SUBJECT: COMANCHE PEAK STEAM ELECTRIC STATION (CPSES)  
DOCKET NOS. 50-446  
TRANSMITTAL OF INSERVICE INSPECTION PROGRAM PLAN  
INTERIM CHANGE REQUEST  
(UNIT 2: 1986 EDITION OF ASME CODE SECTION XI, NO ADDENDA,  
INTERVAL START DATE - AUGUST 3, 1993, FIRST INTERVAL)

Interim Change Request No. ISI-2R0-006

INTERIM CHANGE REQUEST

Plan Title/Rev. Unit 2 ASME Section II Inservice Inspection Program Plan 10 ICR No. 6

Also Available on  
Aperture Card

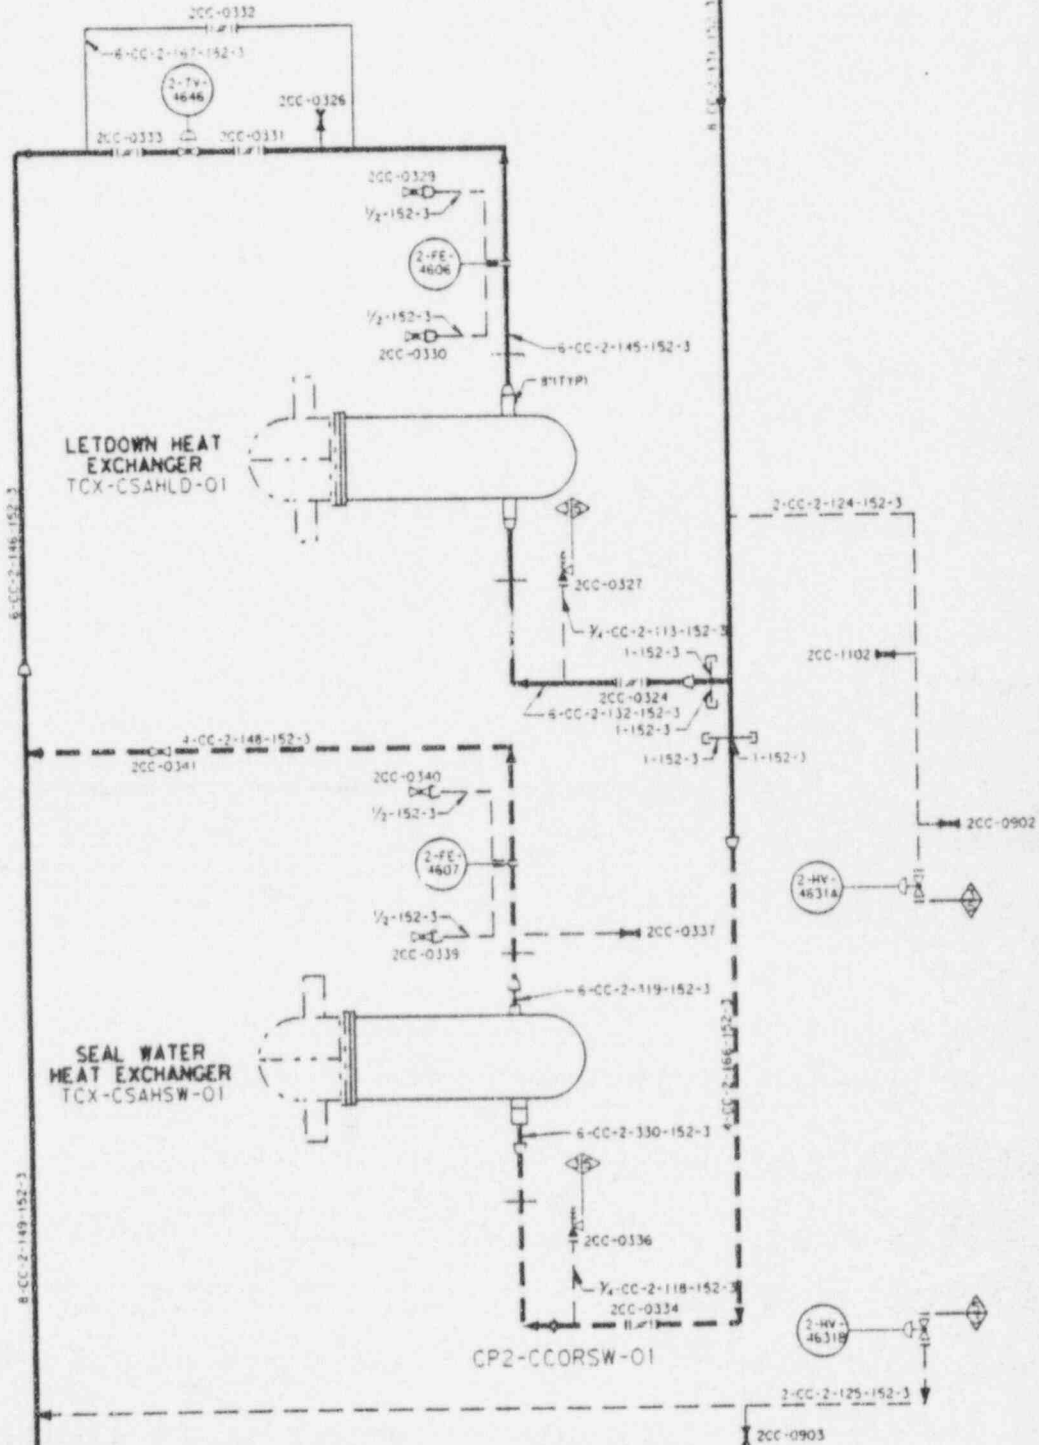
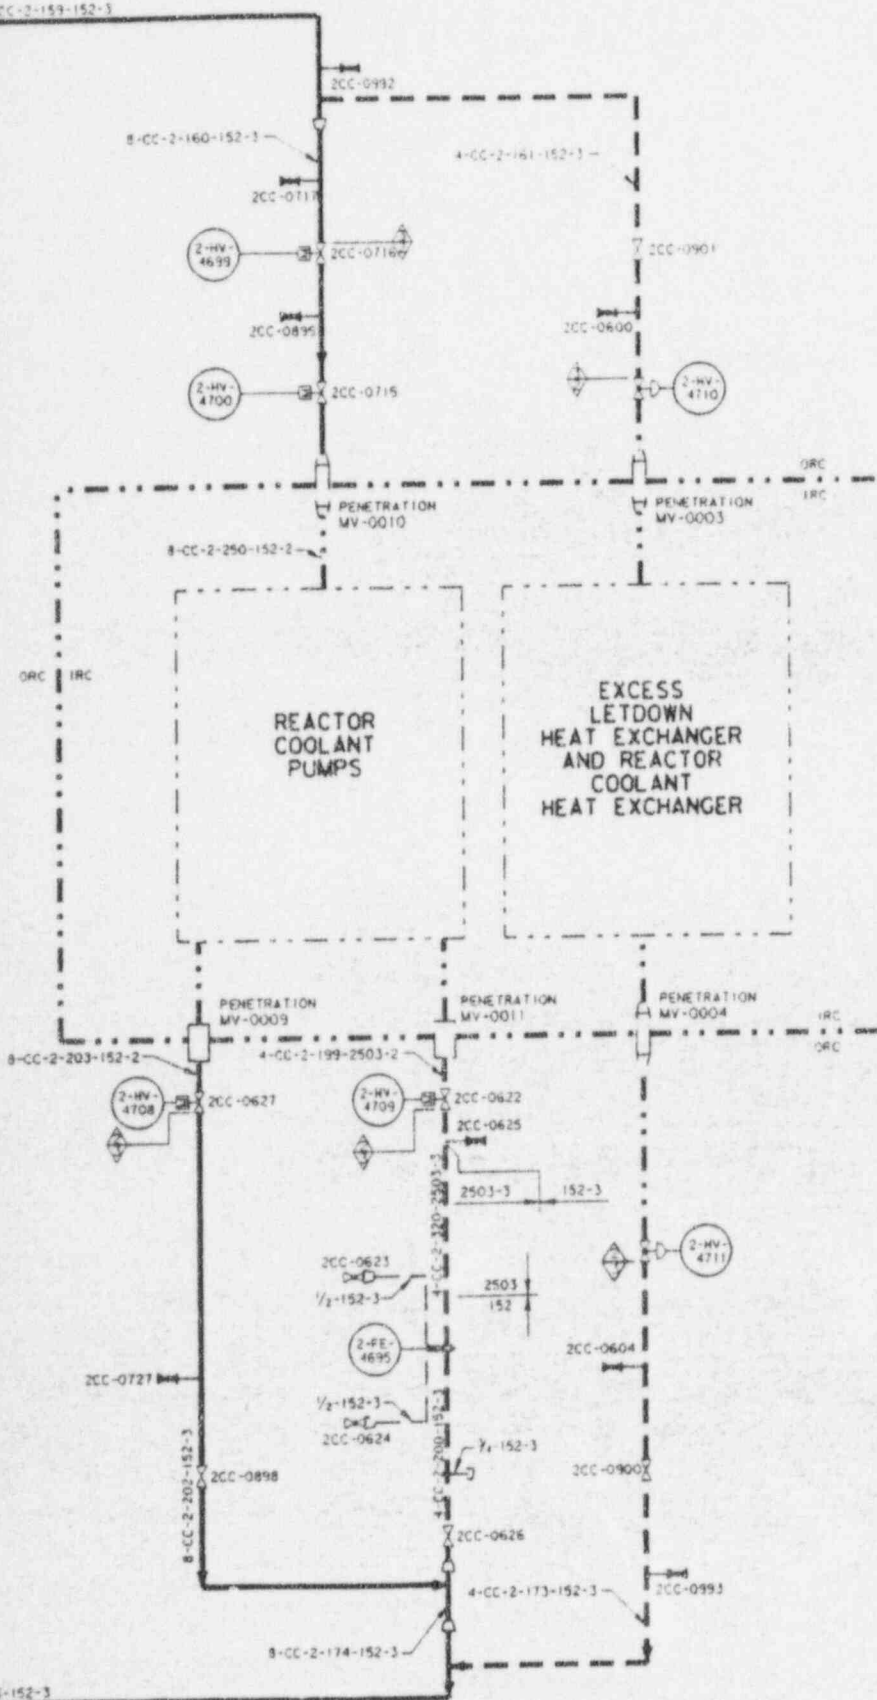
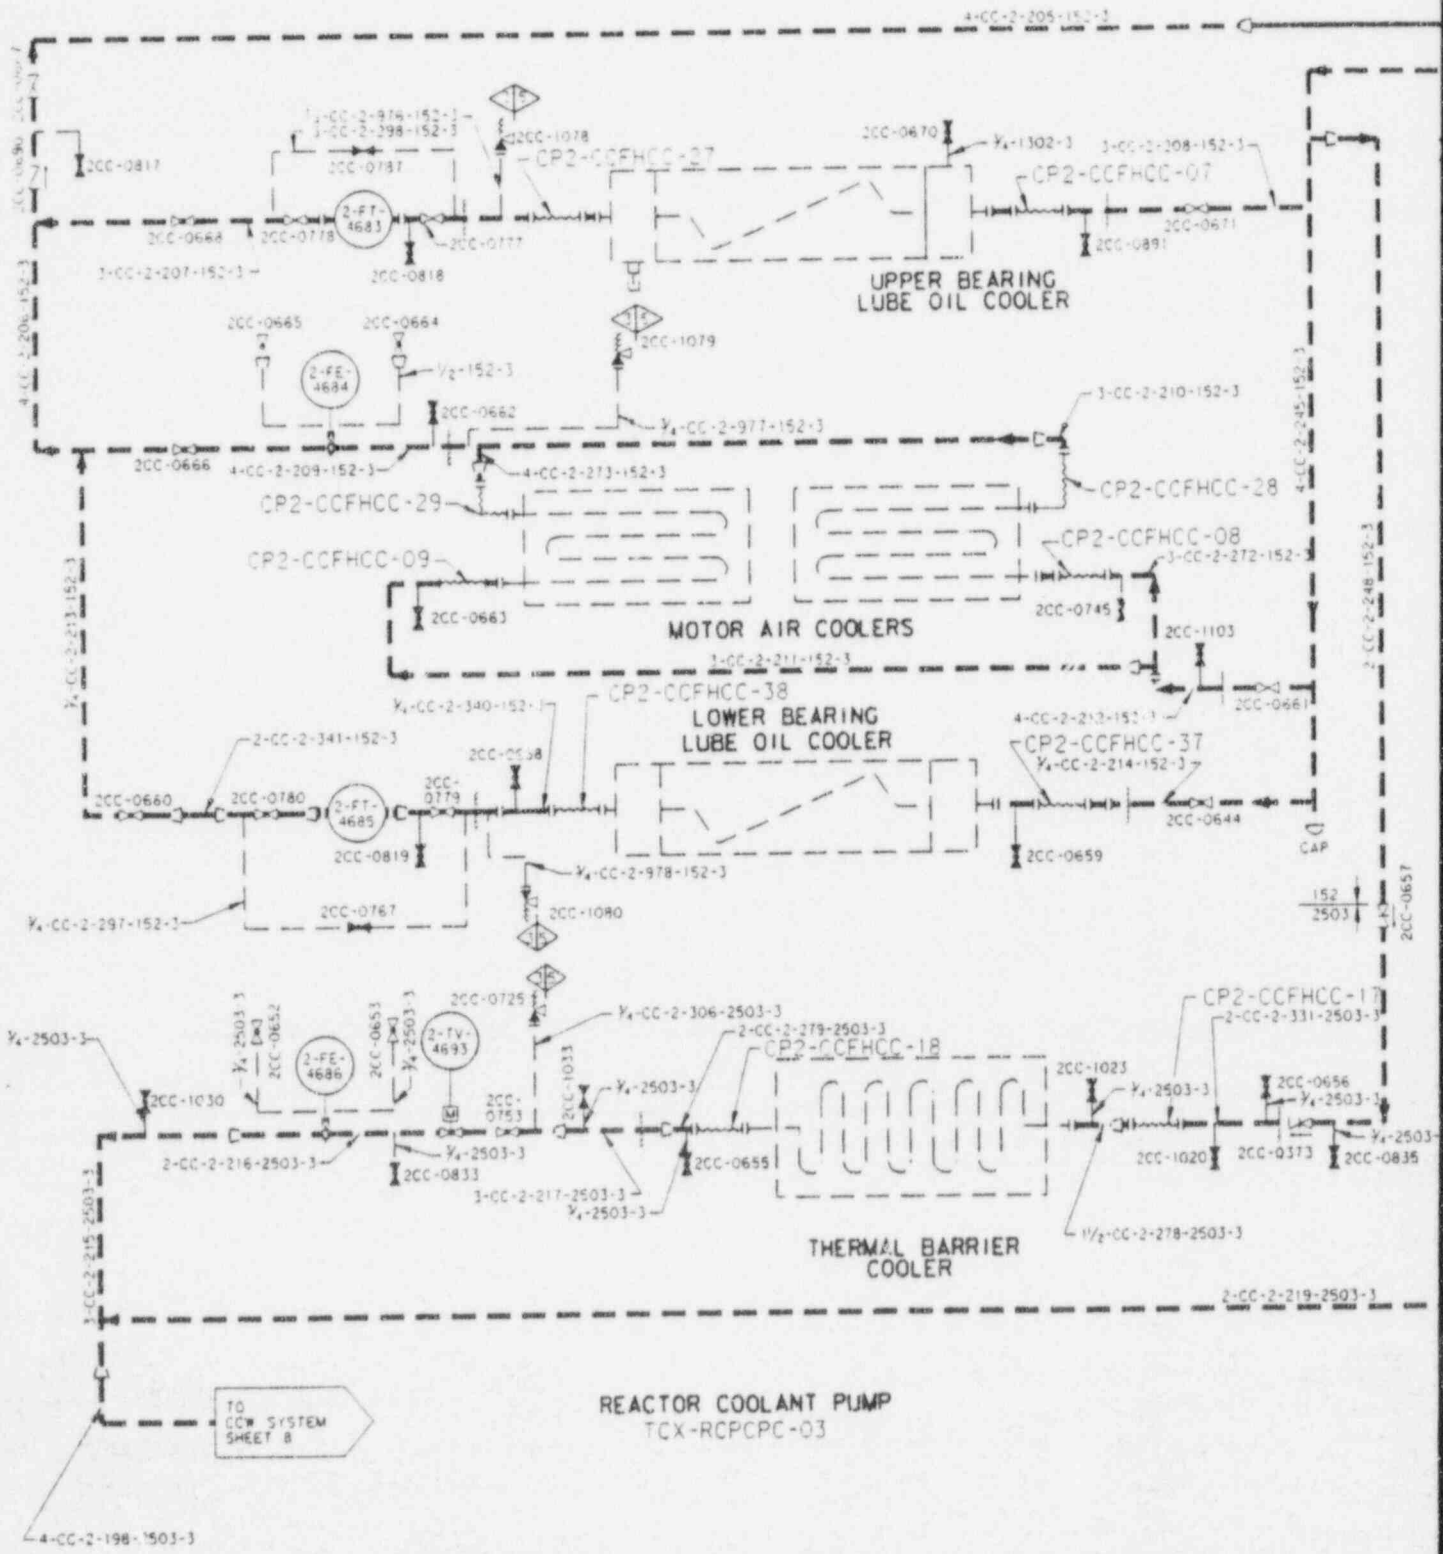
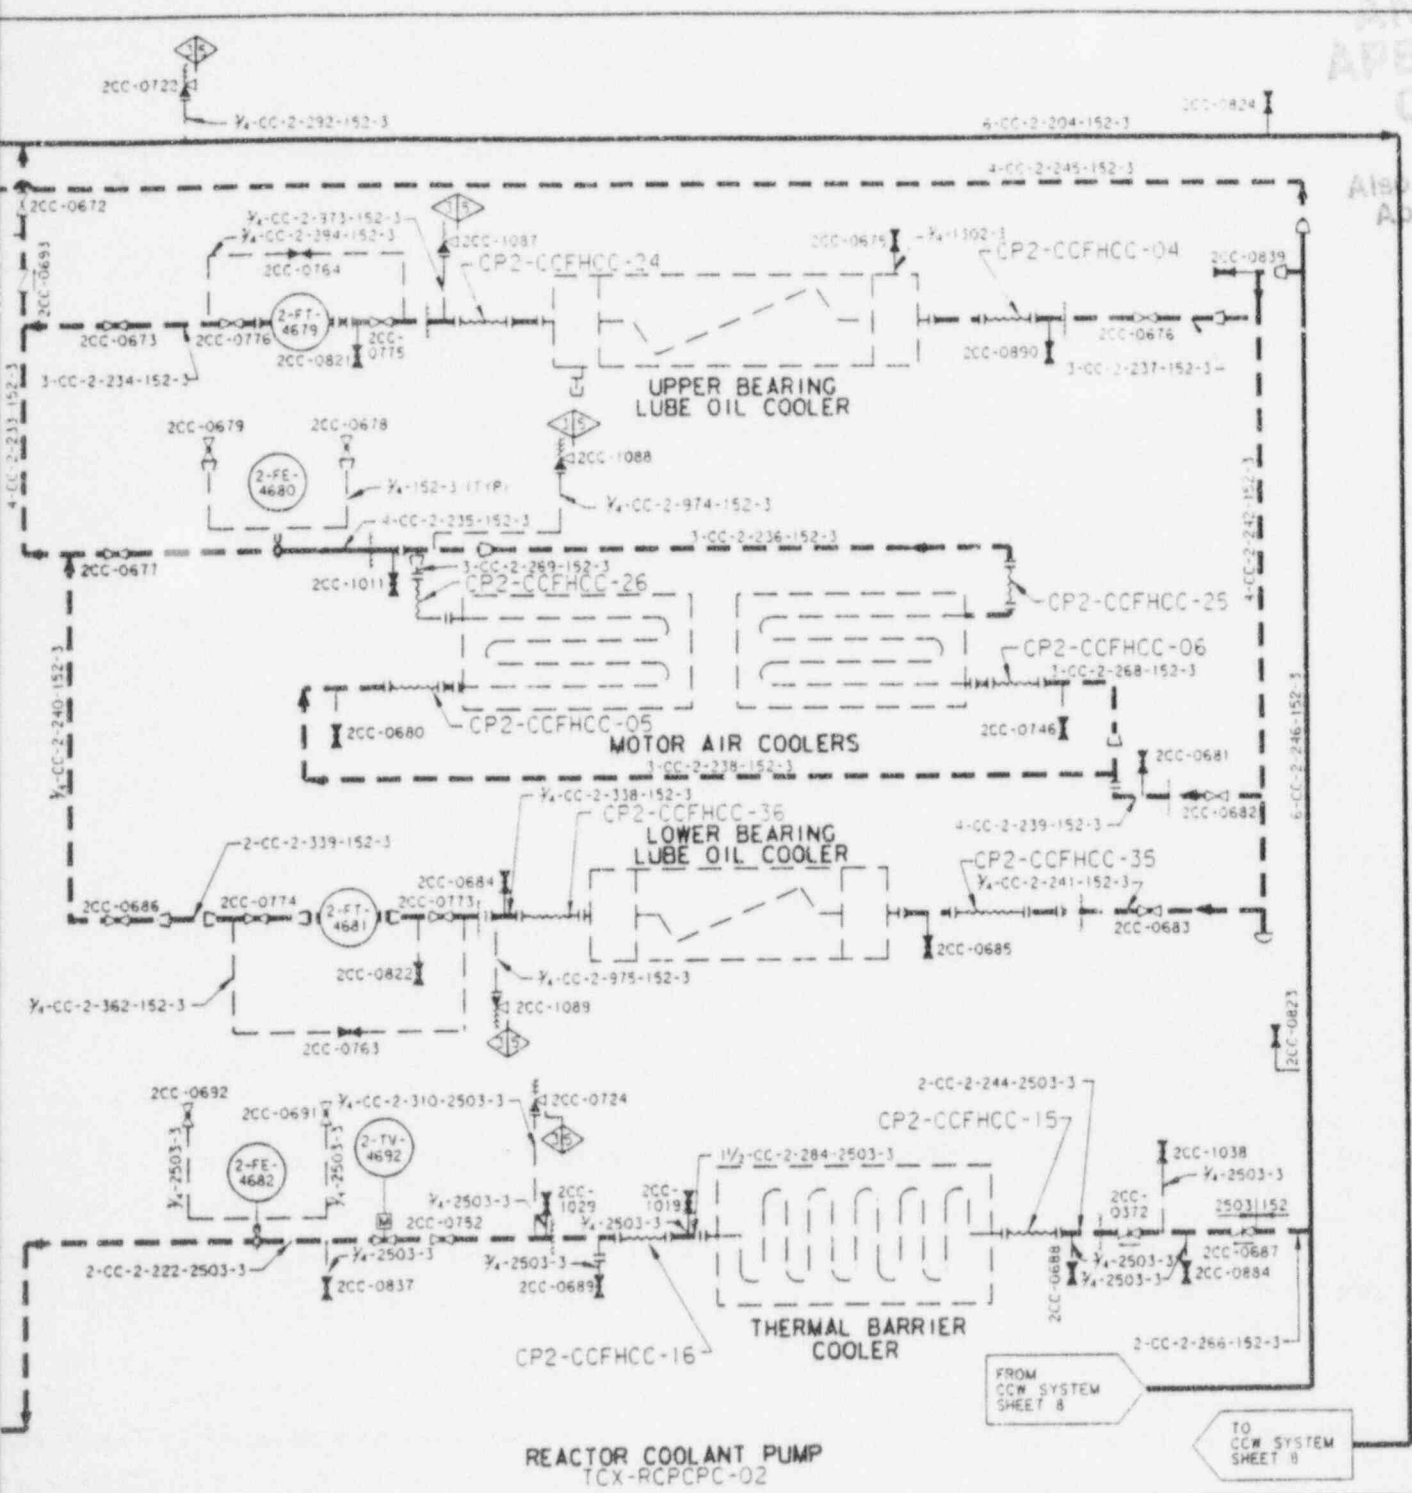
1. CC - Three 24" crossties are provided between Units 1 and 2. Each crosstie is between locked closed butterfly valves. As described in DBD-ME-229, these crossties are not required for any design base accident or safe shutdown. Therefore they do not meet any of the criteria established in Table D-A, D-B or D-C.

The portion of CC which is between containment isolation valves 2-HV-4711 and 2-HV-4710 (both ORC) supplies flow to the shell side of the Reactor Coolant Drain Tank Hx and the Excess Letdown Hx. The Excess Letdown Hx accommodates expansion related flow in excess of the capabilities of normal CVCS letdown during plant heatup. The Reactor Coolant Drain Tank is part of the Waste Processing (WP) system. As described in DBD-ME-264, "Liquid Waste Processing System", the WP system does not perform a safety function. Valves 2-HV-4710/4711 close upon an S-signal. Therefore, the requirements of Category C-H note (7) are met.

Replace Table 9 of Section 5.0 with the attached. Replace the existing drawing with the attached drawings as listed below. A detailed justification of this change is attached.
